ADDENDUM NO. 3

DATED: November 14, 2024

PROJECT:	WSD New Sr. High School	**DATE:**	11/14/2024
OWNER:	Wynne School District	**PROJECT NO:**	A-23010
TO:	Gary Hoyt Nabholz Construction	**CONTRACT FOR**:	General Construction

1 FIRST FLOOR PLAN - AREA A SOUTH - PLUMBING

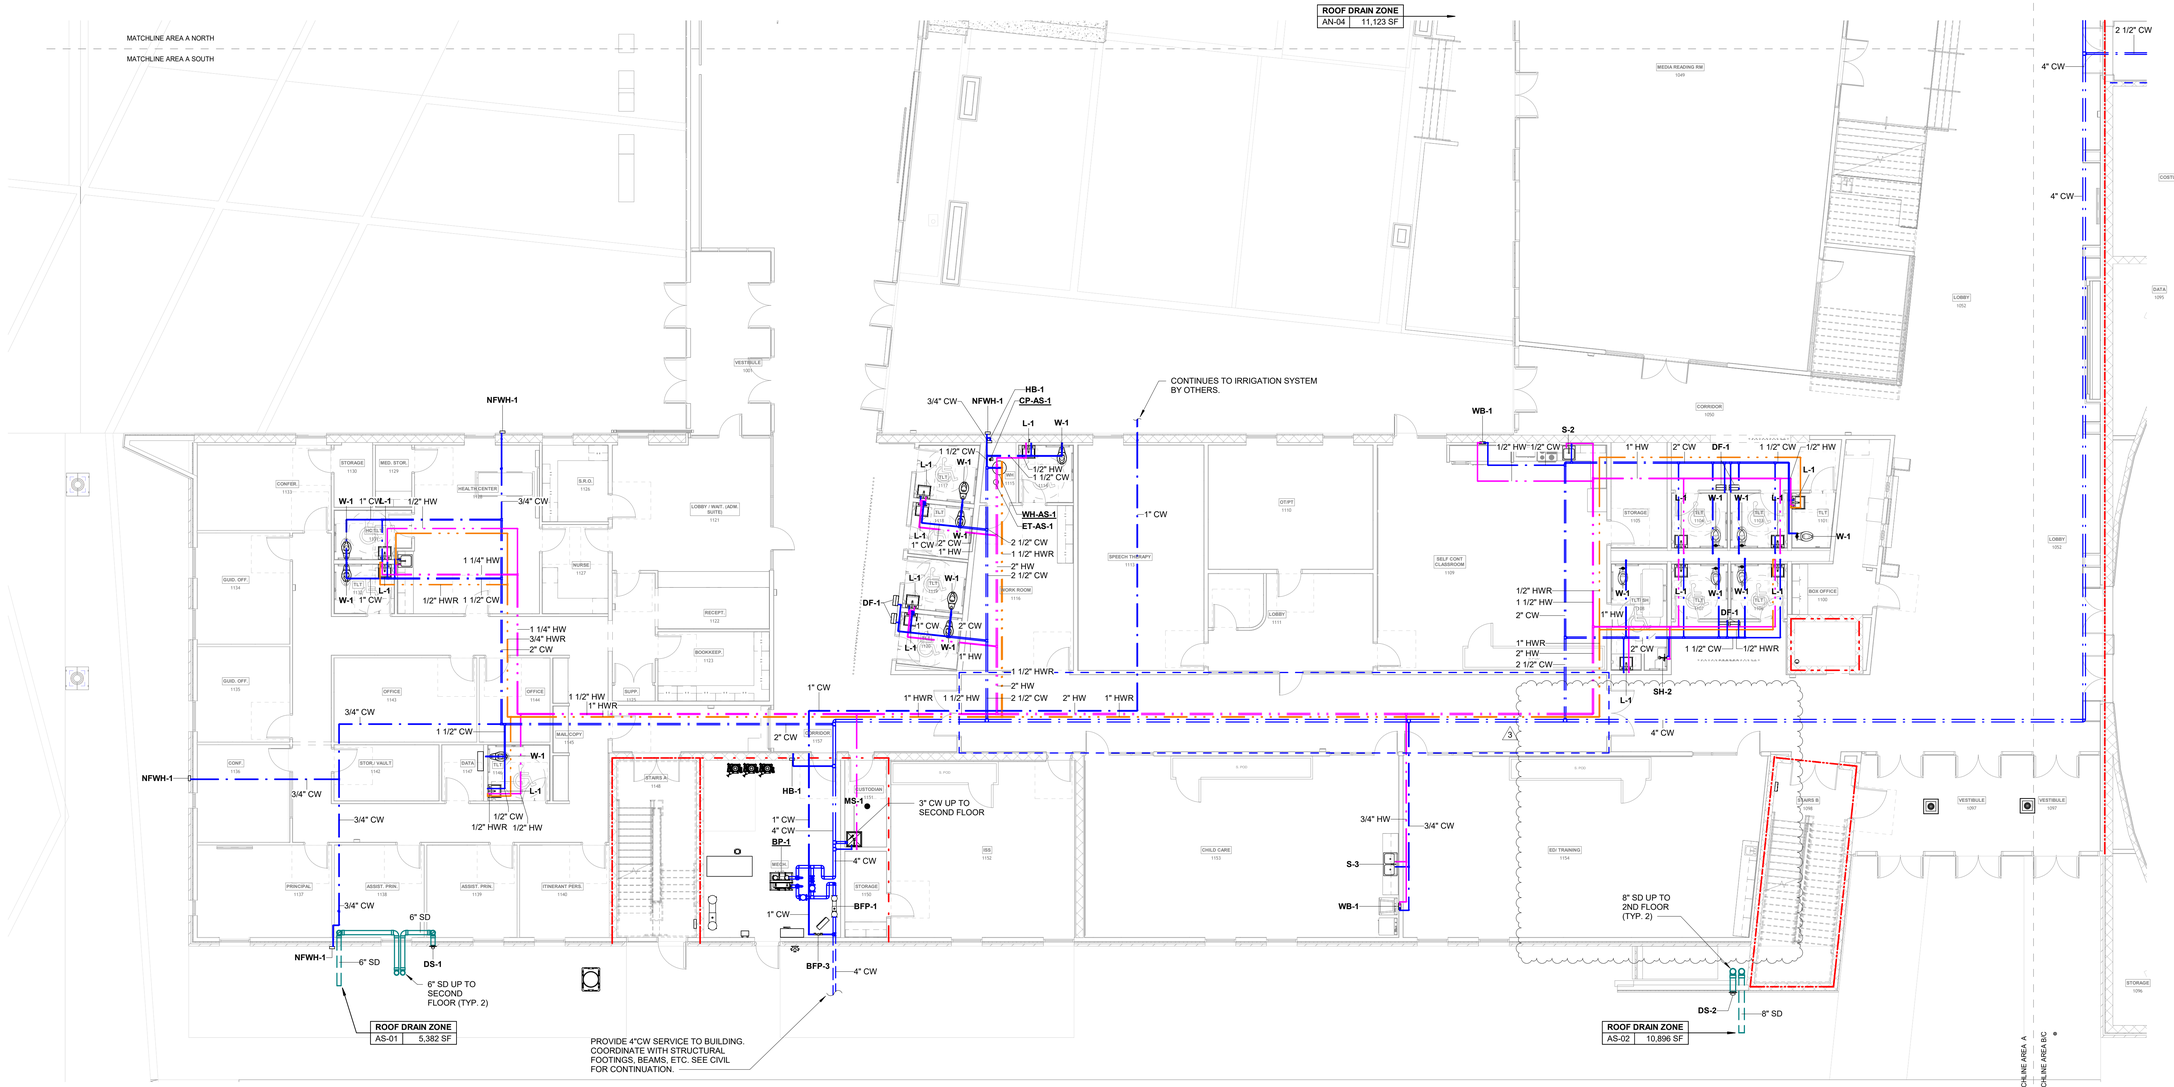
111. Sheet P101.4 FIRST FLOOR PLAN – AREA A SOUTH - PLUMBING: Drawing has been updated and revised as indicated on drawing sheet.
112. Sheet P102.1 SECOND FLOOR PLAN – AREA A NORTH - DWV: Drawing has been updated and revised as indicated on drawing sheet.

1 SECOND FLOOR PLAN - AREA A NORTH - PLUMBING

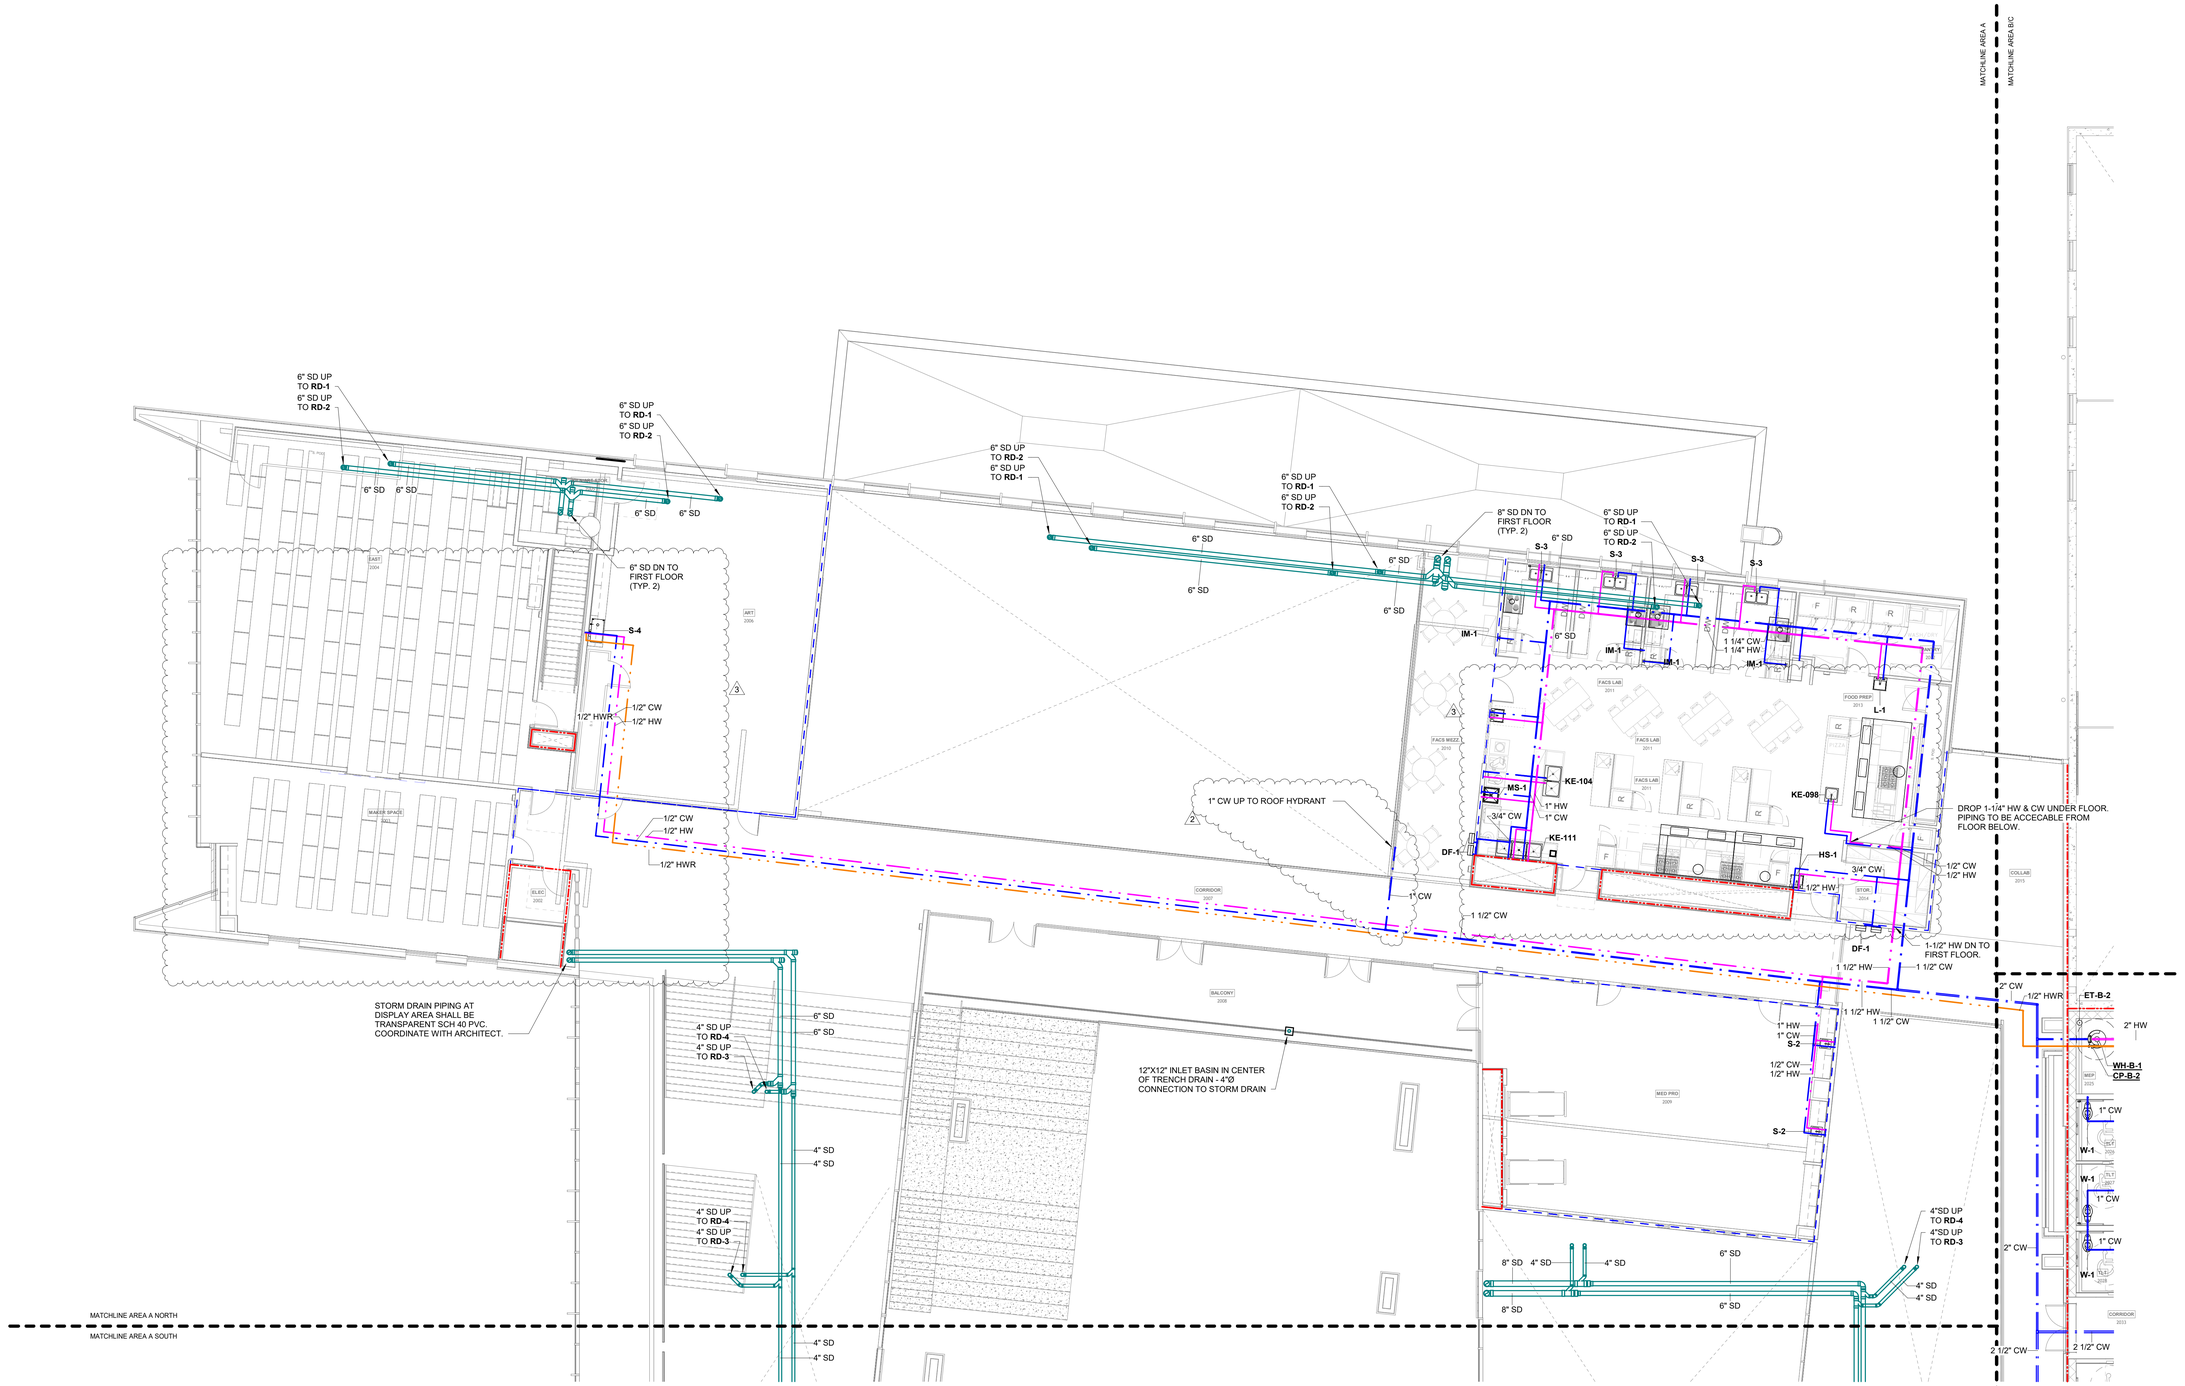
113. Sheet P102.2 SECOND FLOOR PLAN – AREA A NORTH - PLUMBING: Drawing has been updated and revised as indicated on drawing sheet.
114. Sheet P102.4 SECOND FLOOR PLAN – AREA A SOUTH - PLUMBING: Drawing has been updated and revised as indicated on drawing sheet.

1 SECOND FLOOR PLAN - AREA B - PLUMBING

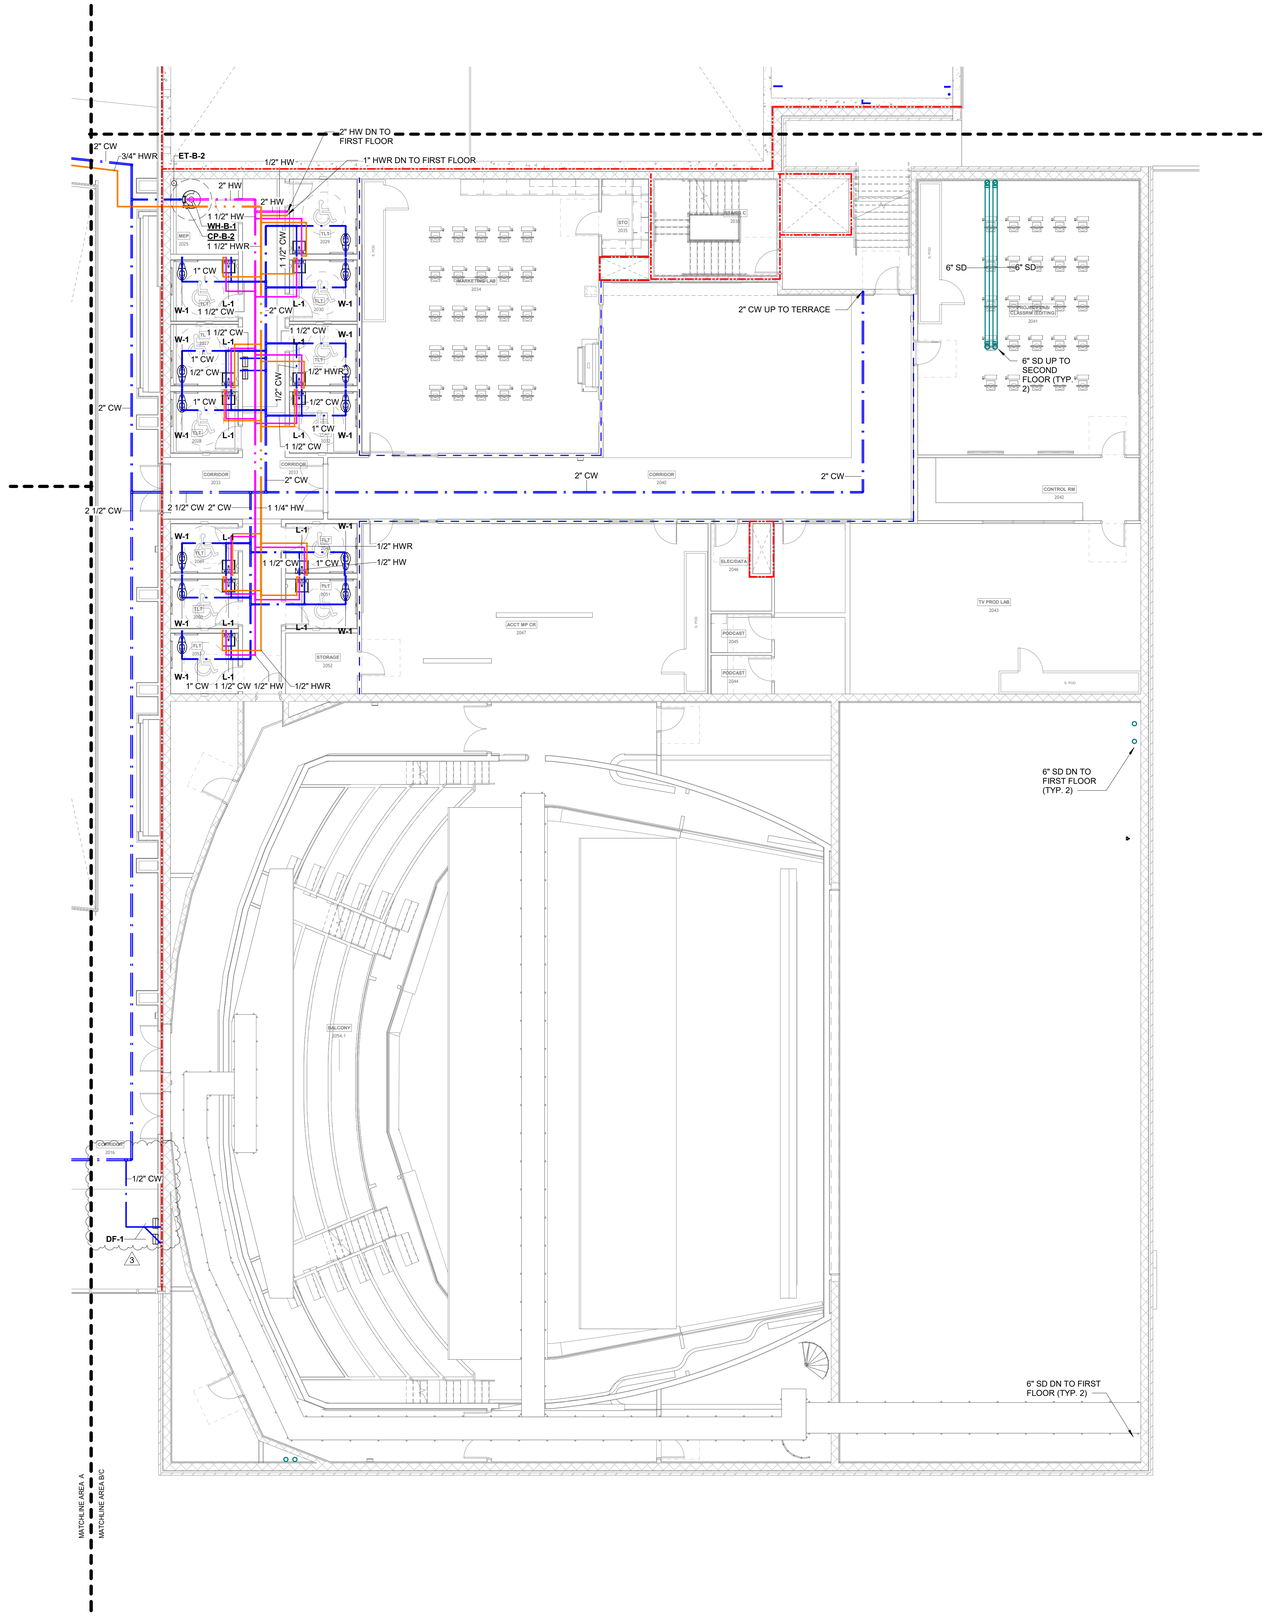
115. Sheet P102.6 SECOND FLOOR PLAN – AREA B - PLUMBING: Drawing has been updated and revised as indicated on drawing sheet.
116. Sheet E001 GENERAL NOTES, SCHEDULES AND LEGEND: Drawing has been updated and revised as indicated on drawing sheet.

1 FOUNDATION PLAN - AREA A SOUTH

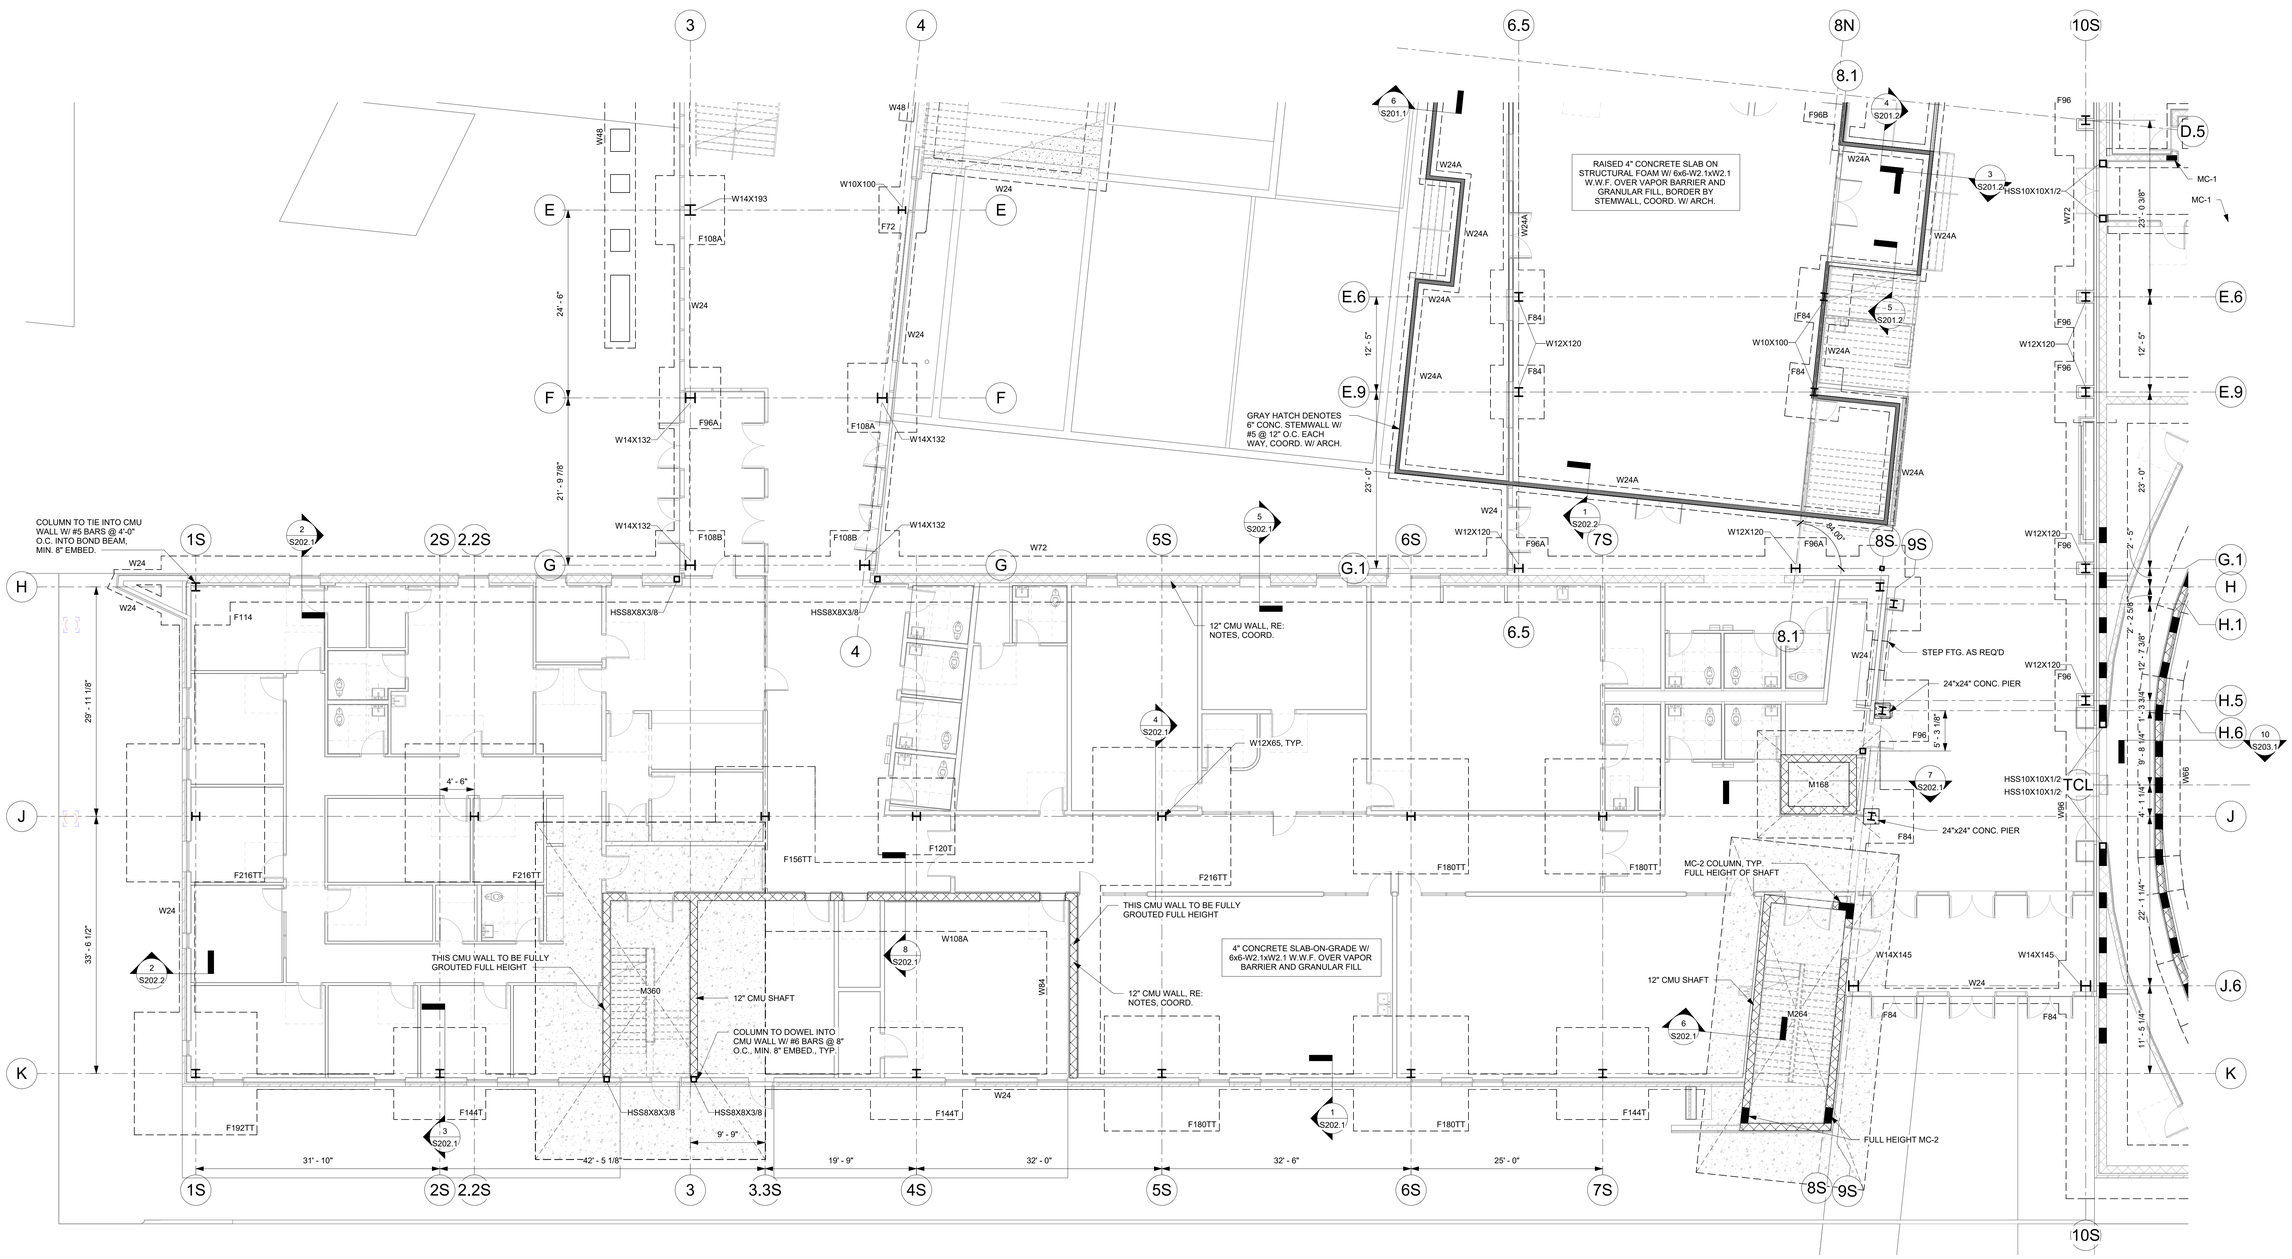
84. Sheet S101.2 FOUNDATION PLAN – AREA A SOUTH: Drawing has been updated and revised as indicated on drawing sheet.
85. Sheet S101.3 FOUNDATION PLAN – AREA B: Drawing has been updated and revised as indicated on drawing sheet.
